ORIGINATION FORM

Proposed Revisions to a Standard Plans Index

Index Number: 550-012
Sheet Number (s): 3 of 4
Index Title: BRIDGE FENCING (ENCLOSED)

VIEW A-A

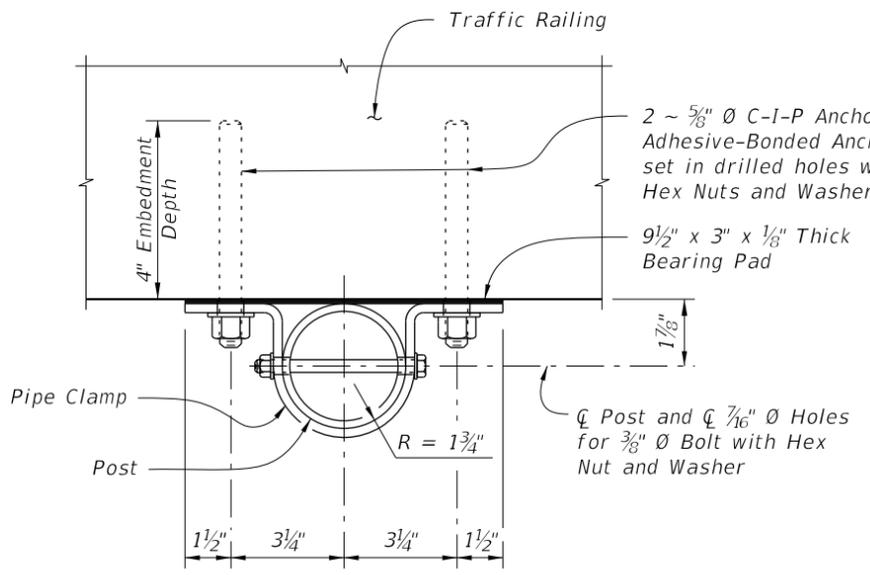
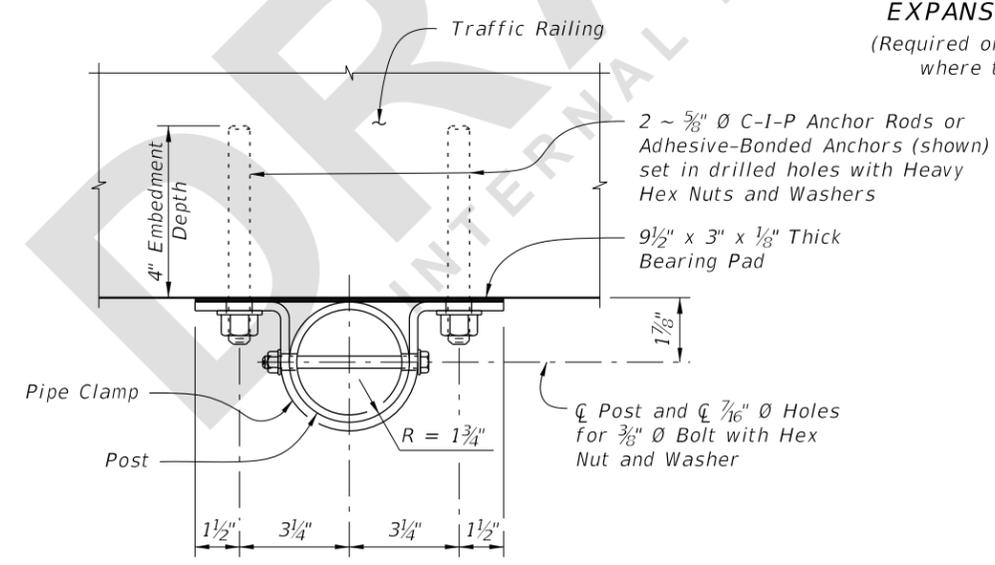
Sheet 3: Change the shim thickness at the base of the pole to indicate that it varies based on railing type.
